BUILDING INSPECTION PERMIT

This is to certify that Wescott & Payson Li/Chris Ballard
has permission to Construct 2424 s.f. Single family dwelling w/2 car garage
AT 36-38 Yale St (Lot #2 University Park) CITY OF PORTLAND
OBL 436 A012001

City of Portland, Maine - Building or Use Permit

RE: 36-38 Yale Street (lot #2 University Park) – 436-A-012 & 1/2 of 13 – R-3 Zone
Permit application #03-0894

FIRST FLOOR PLAN

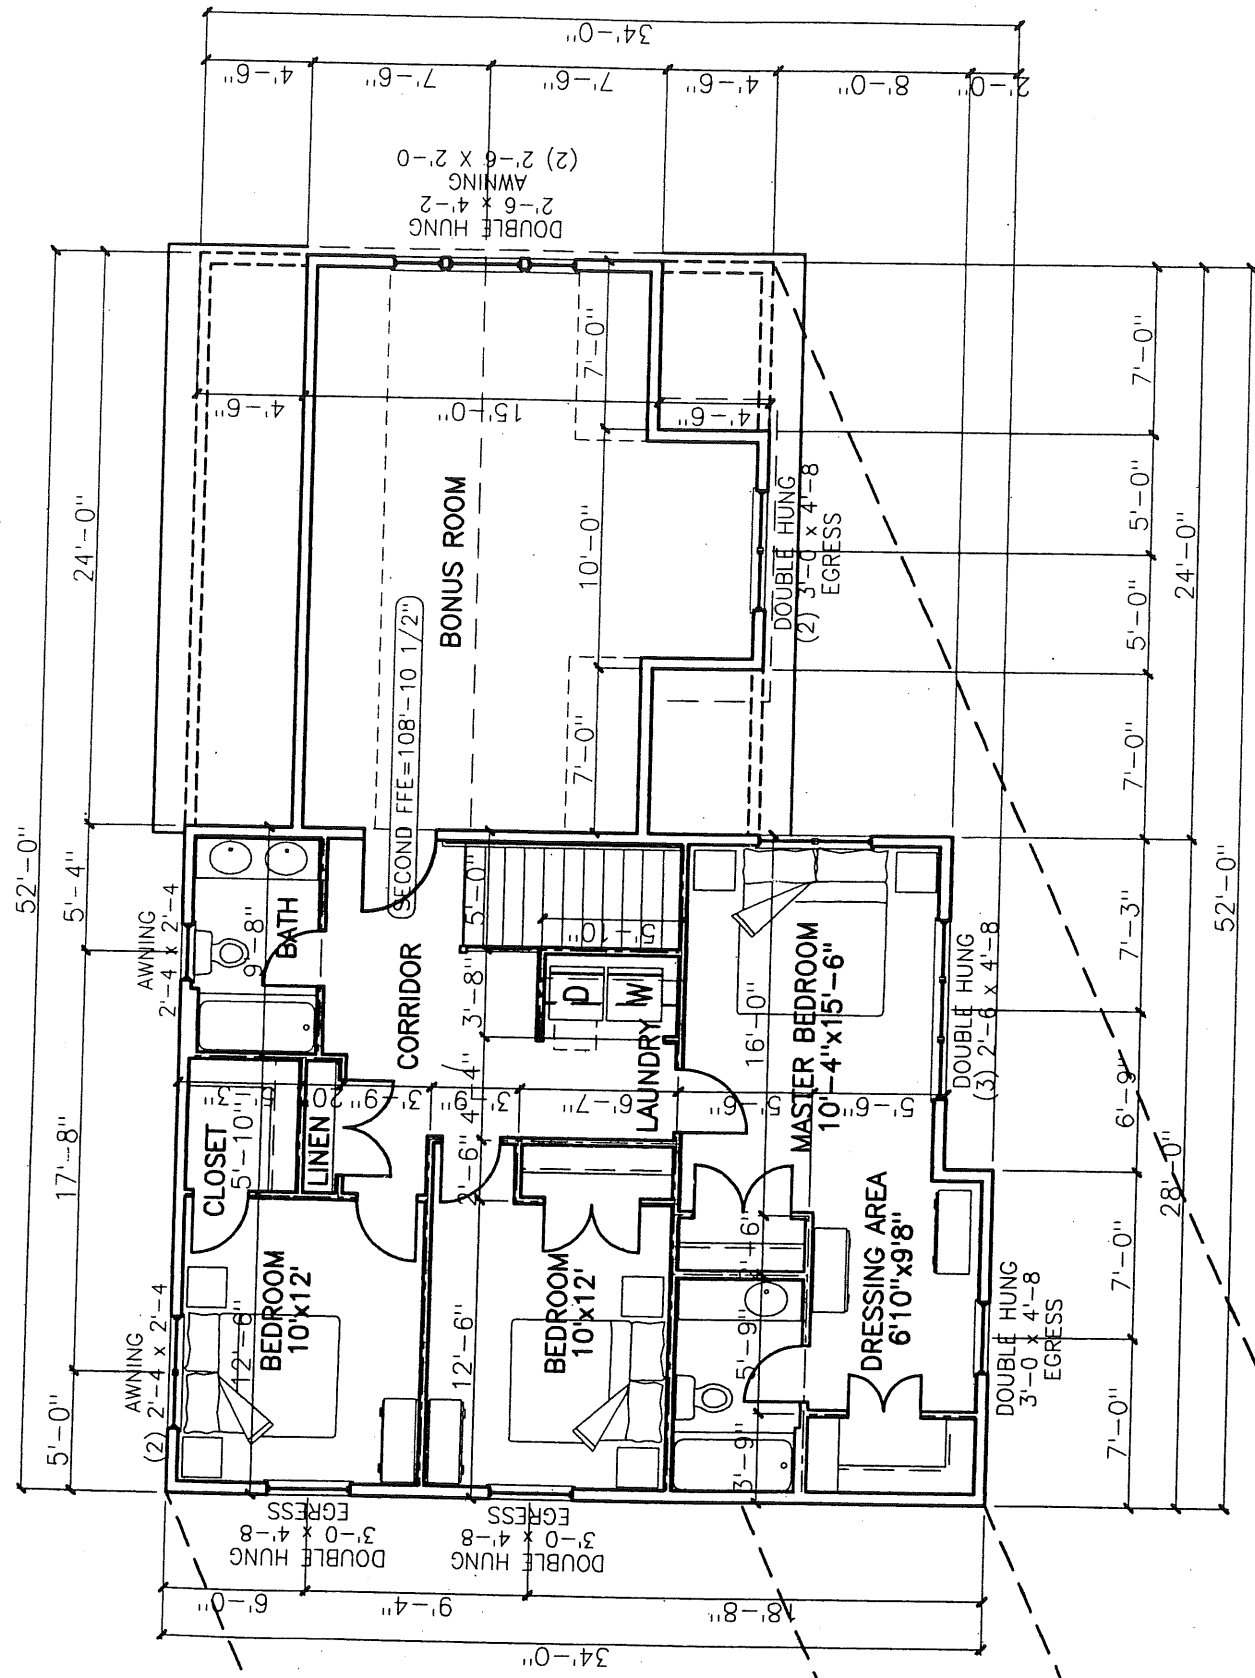
See Revised Plans Building Detail 9/3/03

See Revised Plans Building Detail 9/3/03
